# Spokane Plan Commission Agenda

September 25, 2019

**BRIEFING PAPER**  
**City of Spokane**  
**Plan Commission**  
**Workshop**  
**September 25, 2019**

# SHADLE AREA PLAN EXECUTIVE SUMMARY

**Figure 2: Interim Belt St. Frontage prior to Reconstruction/Redevelopment**

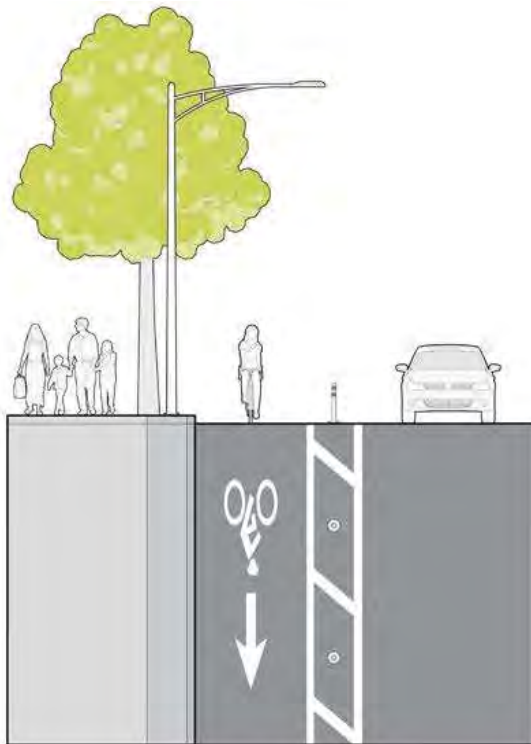
2. On Belt Street – **interim installation** prior to street reconstruction or adjacent property redevelopment
  - a. Recommended street cross-section including:
    - i. Installation of protected bike lanes in the existing parking lane
    - ii. Maintain 8' bike lane width and 2-3' wide painted buffer with vertical, flexible delineator posts to provide physical separation
    - iii. Please see the cross-section below as an example of the temporary bike lane installation. The sidewalk would remain in the current format, immediately adjacent to the curb and gutter.

5. Map of Recommendations
- a. Please see the attached area map of comments.

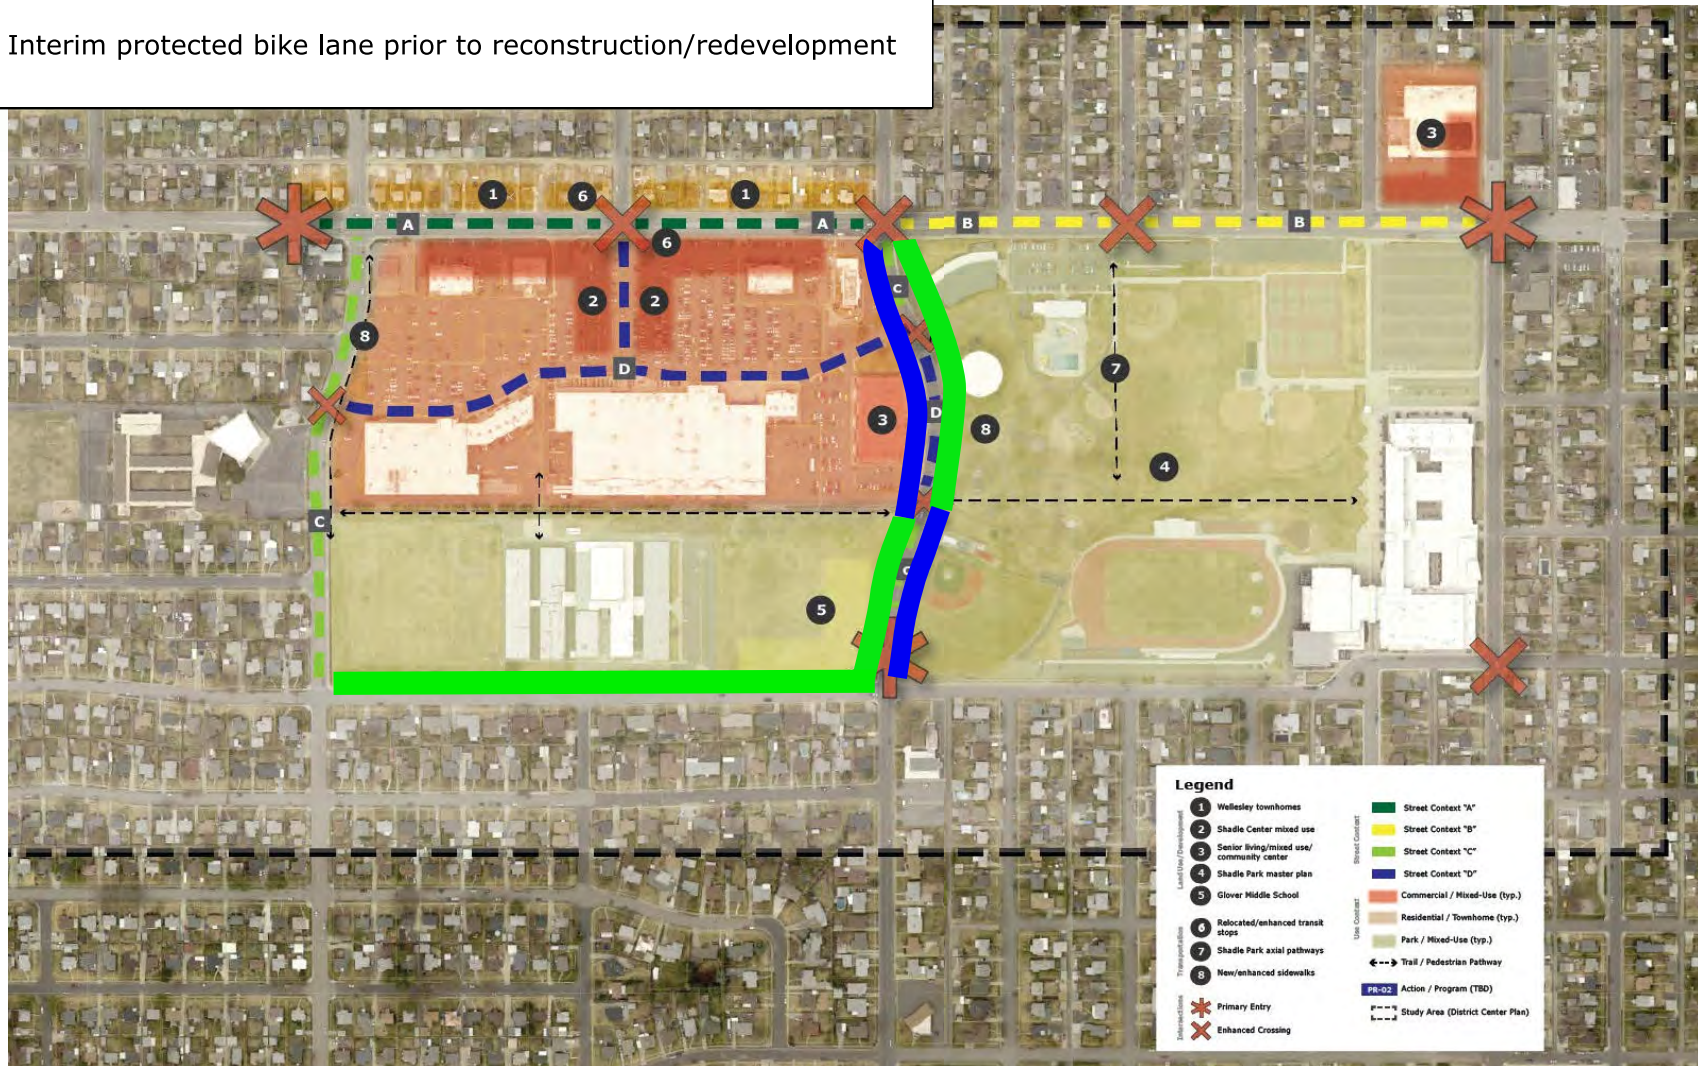
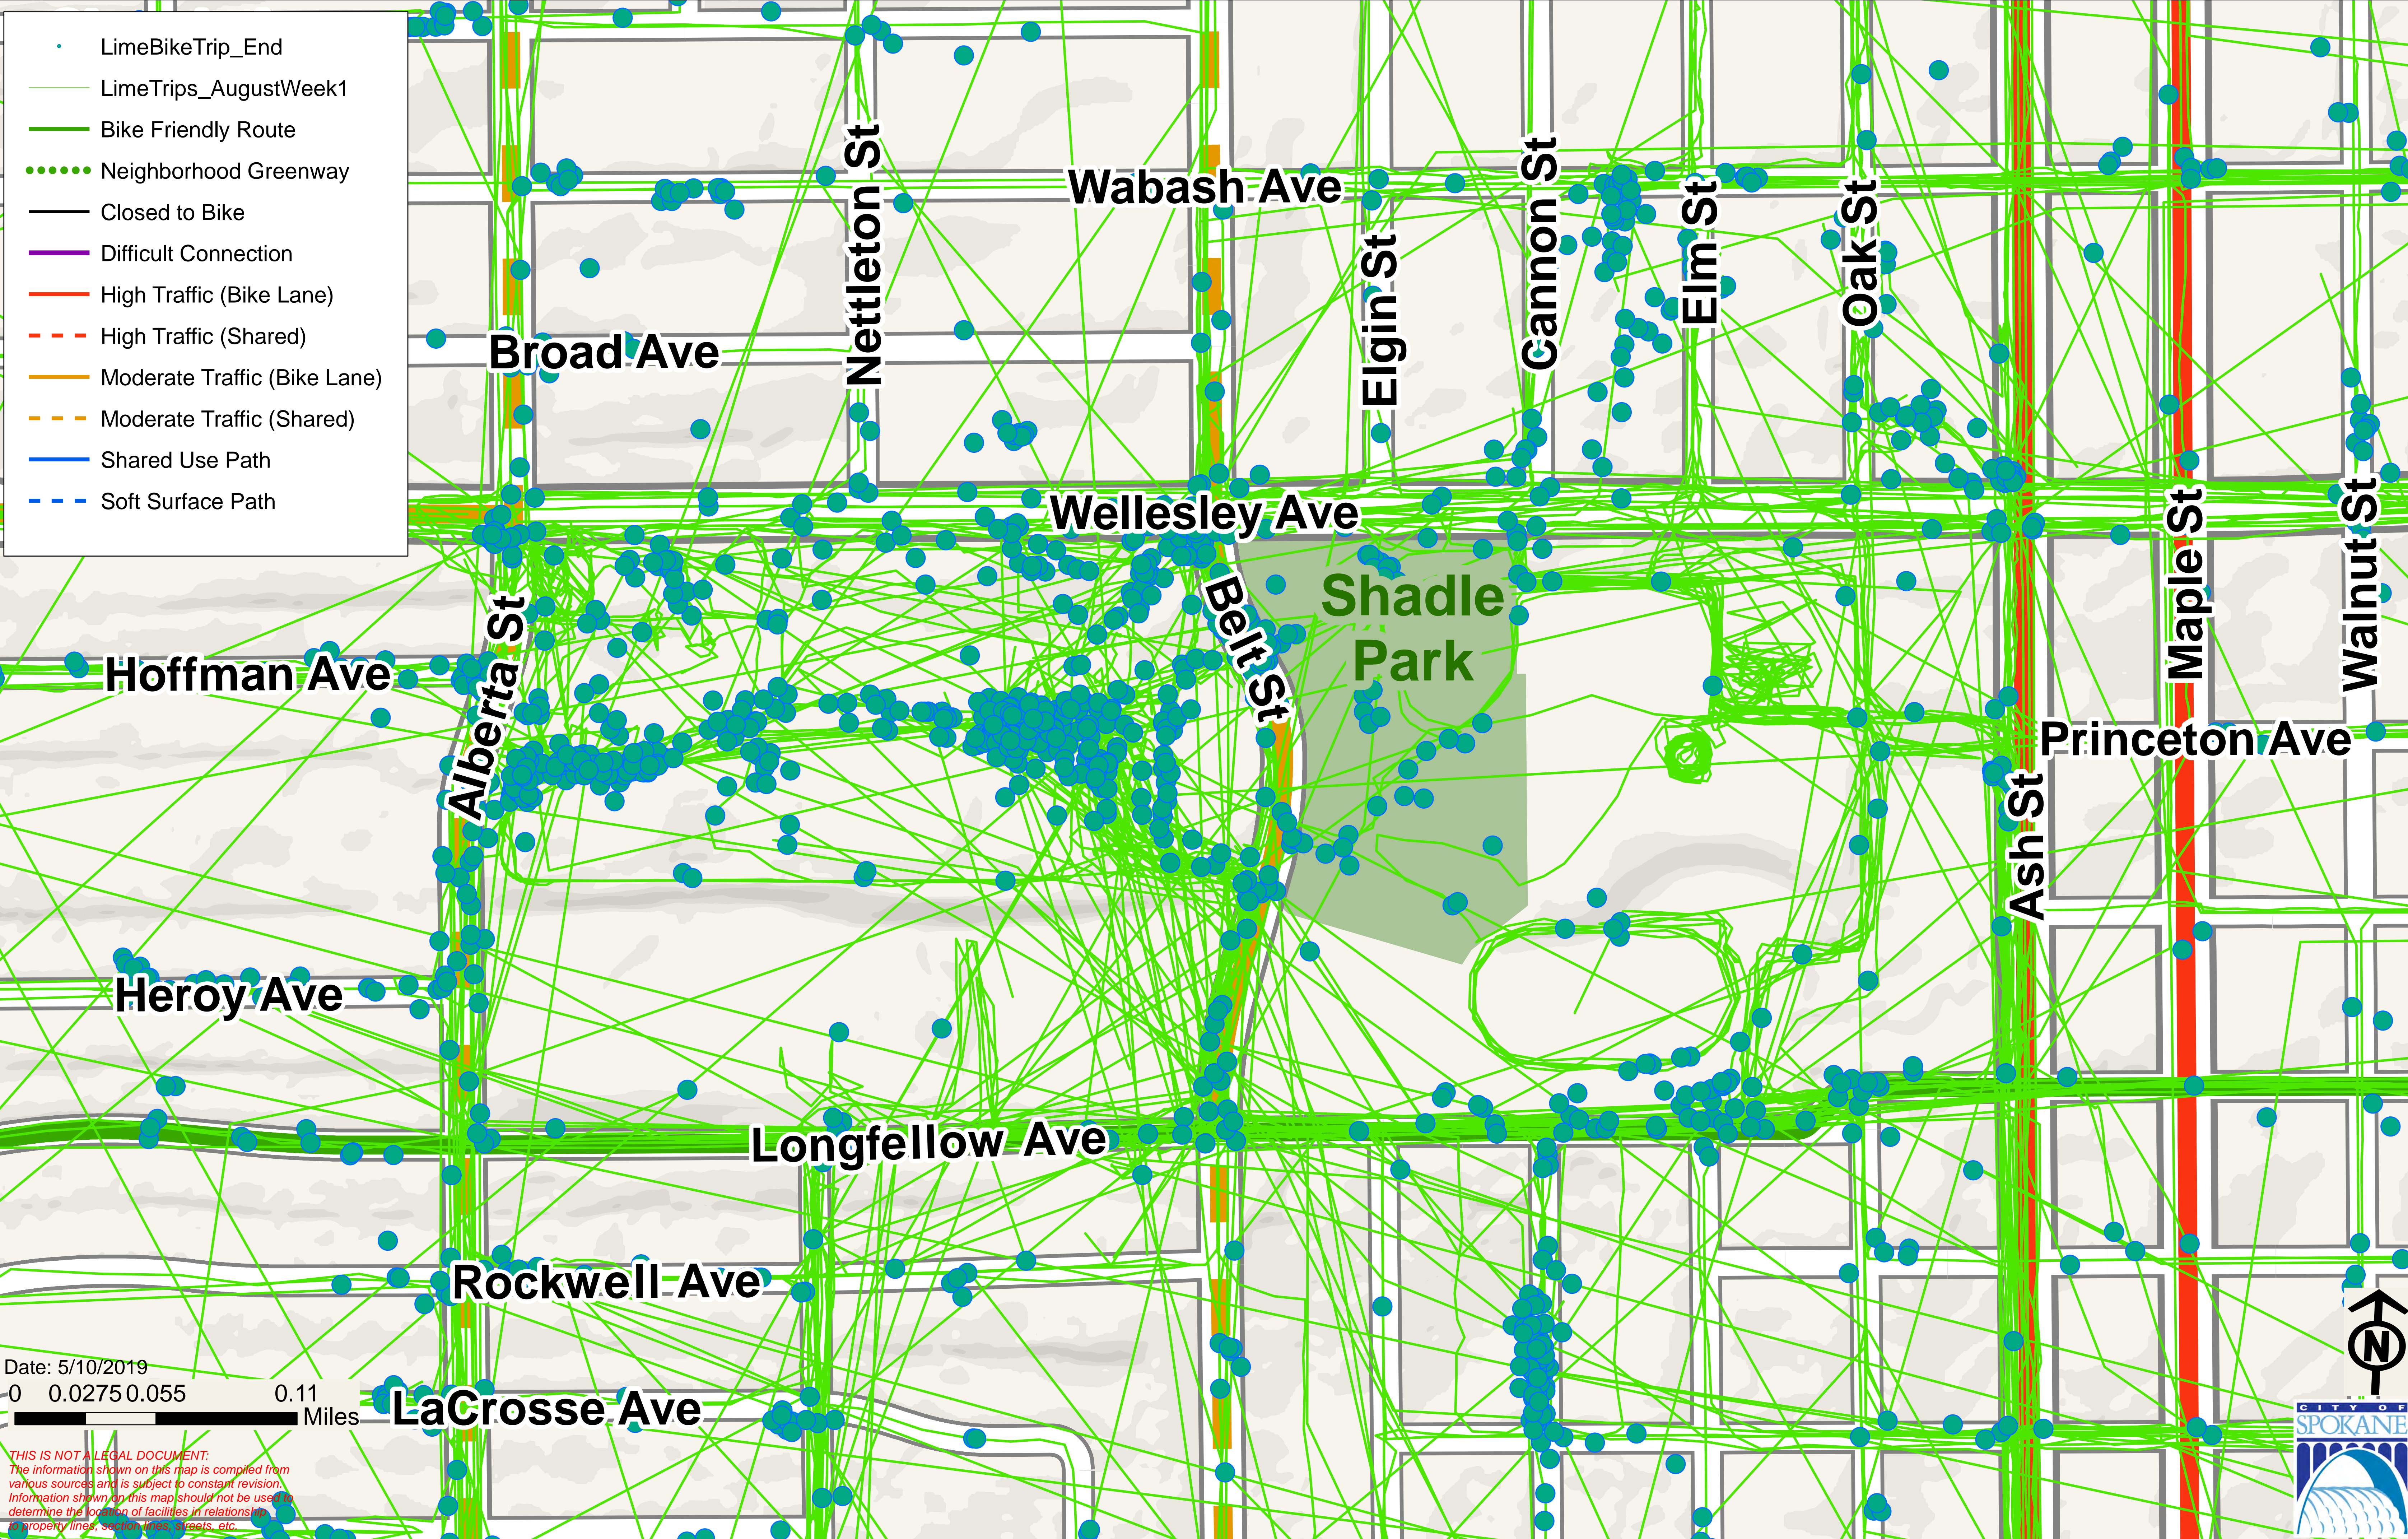
- Protected bike lane with reconstruction/redevelopment
- Interim protected bike lane prior to reconstruction/redevelopment
